T10/04-383r1

Subject  
FCP-3 Clarification to TPRLO

Date  
07 November, 2004

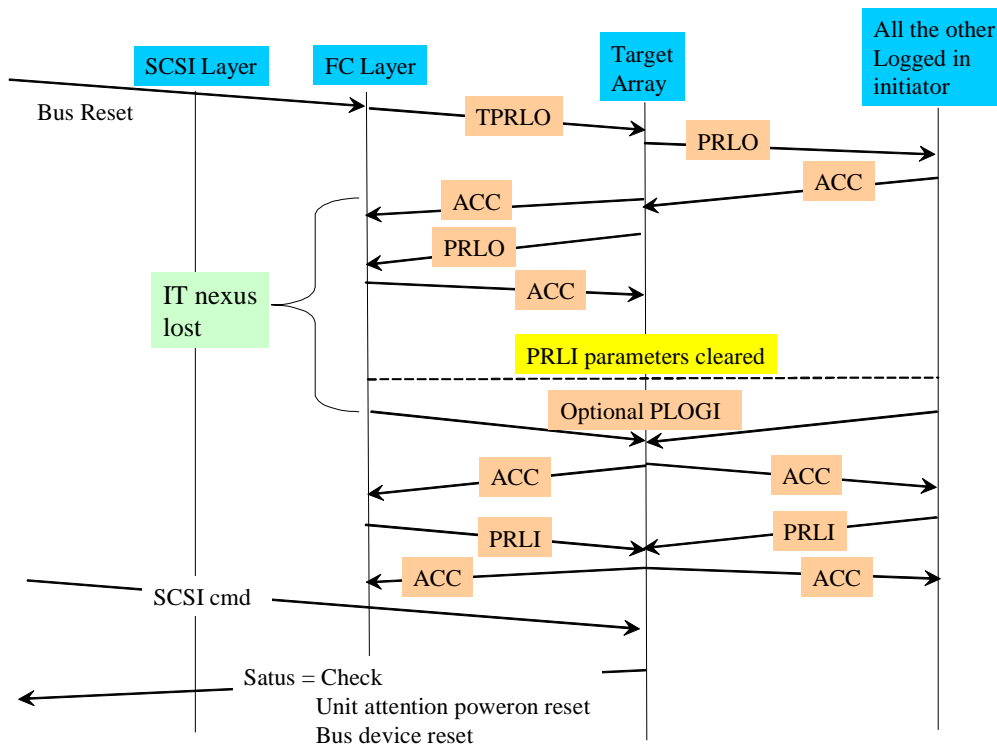
HP has become aware that some target devices do not log out all initiators during a Third Party Process Logout when the GLOBAL bit is set to one. This behaviour results in PRLI parameters remaining set. HP believes that the diagram below shows the correct behaviour.
